STAFF RECOMMENDATION
1826 5th Avenue N
August 18, 2021

Application: New Construction – Infill
District: Salemtown Neighborhood Conservation Zoning Overlay
Council District: 19
Base Zoning: R6-A
Map and Parcel Number: 08108026900
Applicant: Jeff Zeitlin
Project Lead: Joseph Rose, joseph.rose@nashville.gov

Description of Project: Application is to construct a new duplex infill and two three hundred and fifty square foot (350 sq. ft.) garages.

SITE PLAN (1)

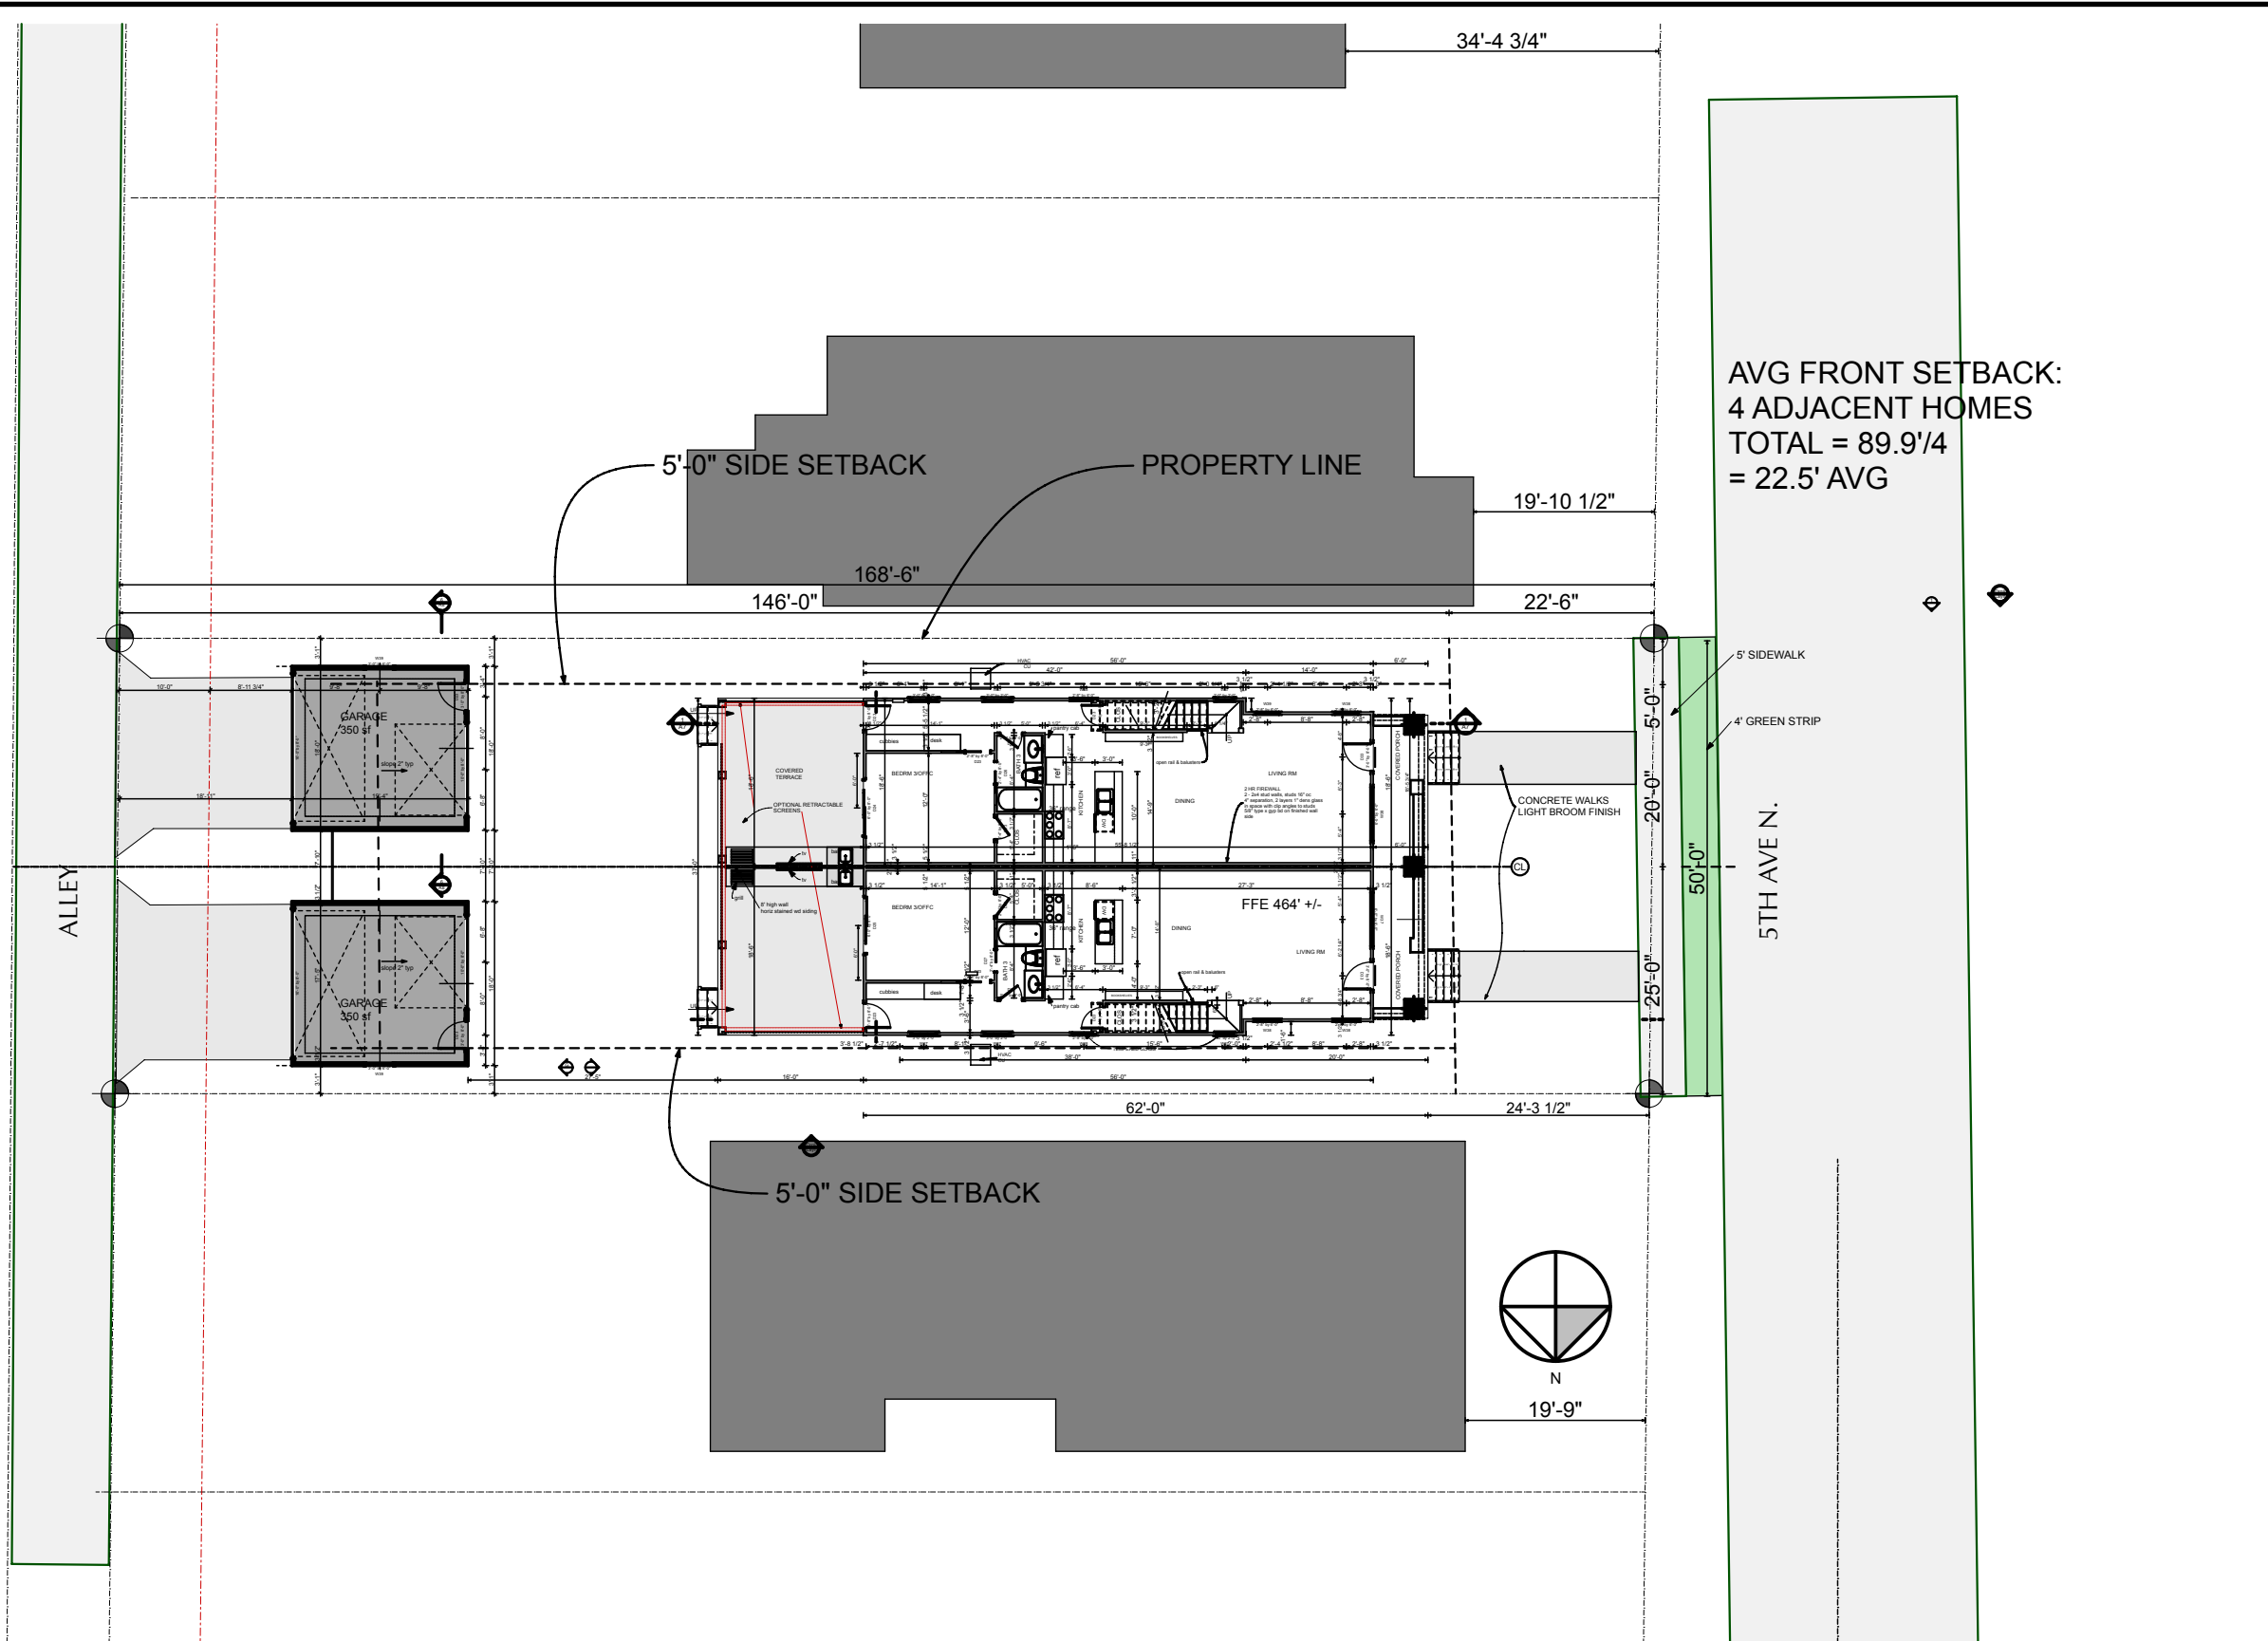
Siting, Setback, Orientation & Rhythm of Spacing: The primary building is centered on the lot and will have a front setback of approximately twenty-two feet, six inches (22’-6”), which is similar to the houses on either side of the site. The infill will be five feet (5’) from the property lines on either side, approximately fifty-six feet (56’) from the rear property line, and twenty-seven feet, five inches (27’-5”) from the outbuildings, meeting the zoning requirements for setbacks.

The garages meet the base zoning setbacks and will be accessed via the alley.

Appurtenances & Utilities: The site plan shows that each of the two HVAC units will be placed on the side facades, almost to the rear of the house. Staff finds that these locations are appropriate and meet section V.C.11. of the design guidelines.

ROOF PLAN

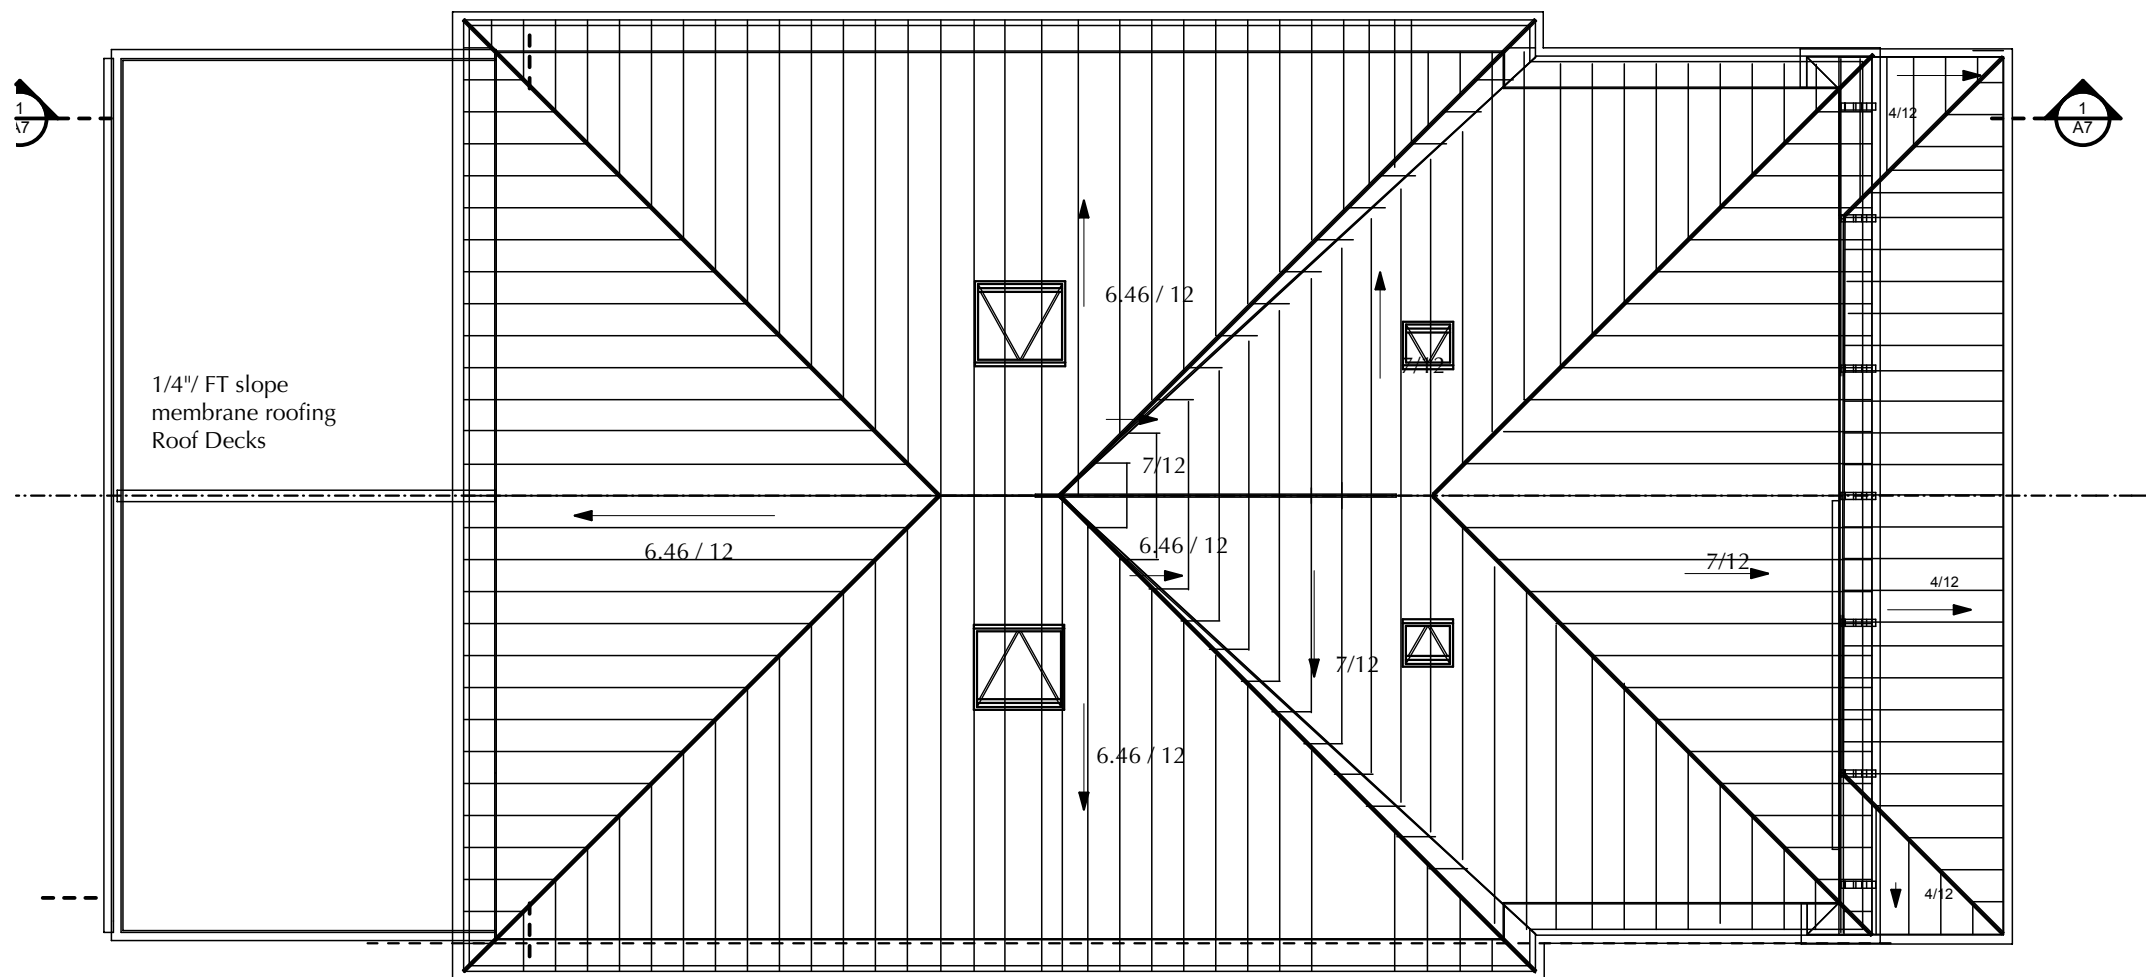
Form: The duplex has a hipped roof form. The front portion of the roof has a 7/12 pitch and the rear, wider portion has a 6.5/12 pitch. The porch roof will also be hipped with a 4/12 pitch.

The project includes skylights, not more than one on one plane, that are parallel with the existing roof plane and with a flat profile, which are a type of skylight that has been approved in the past.

GARAGES

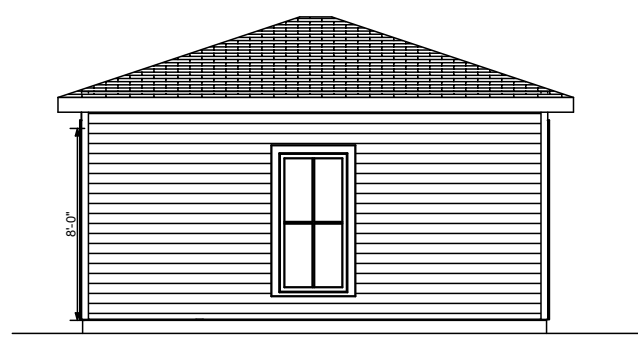
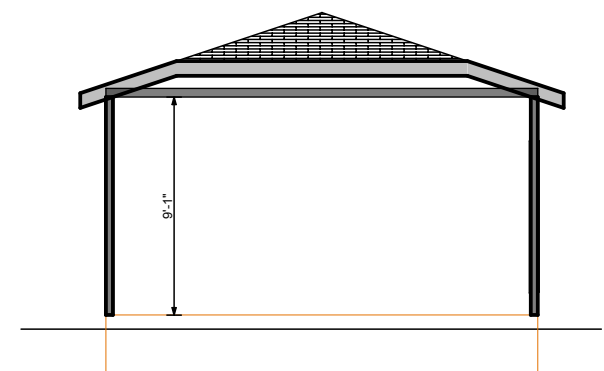
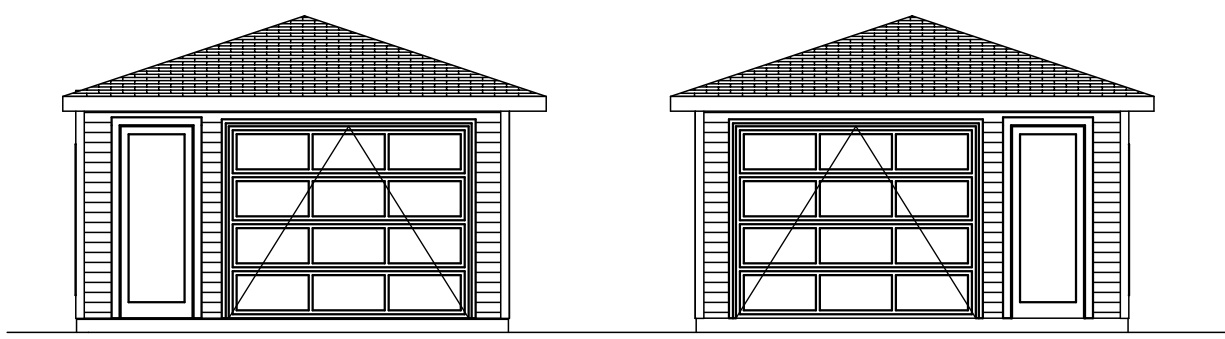
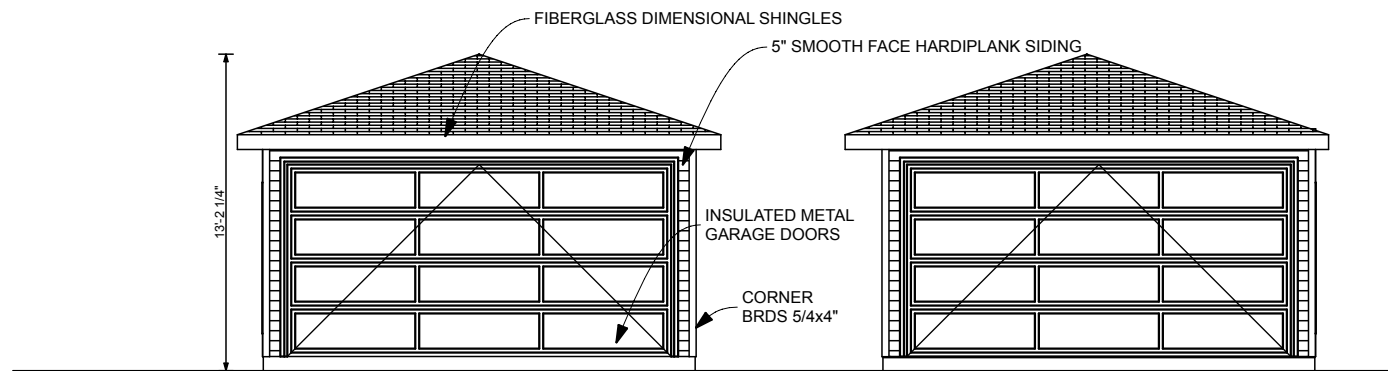
Outbuildings: The applicant is proposing to construct two separate, one story garages that are three hundred and fifty-square feet (350 sq. ft.) each.

Allowed	Proposed
Footprint	Max. 750 sq. ft.	700 sq. ft.
Ridge Height	Max. 25'	13'-2 1/4"
Wall Height	Max. 12'	9'
Foundation Height	Max. 1' where grade is highest	8"
Eave Depth	Max. 2'	1'

Allowed	Proposed
Left Side Setback	Min. 3' if under 700 sq. ft.	3'-1"
Right Side Setback	Min. 3' if under 700 sq. ft.	3'-1"
Rear Setback	Min. 5'	8'-11 3/4"
Distance between primary structure and outbuilding	Min. 20'	27'-5"
Distance between outbuilding and any other building	Min. 6'	7'-10"
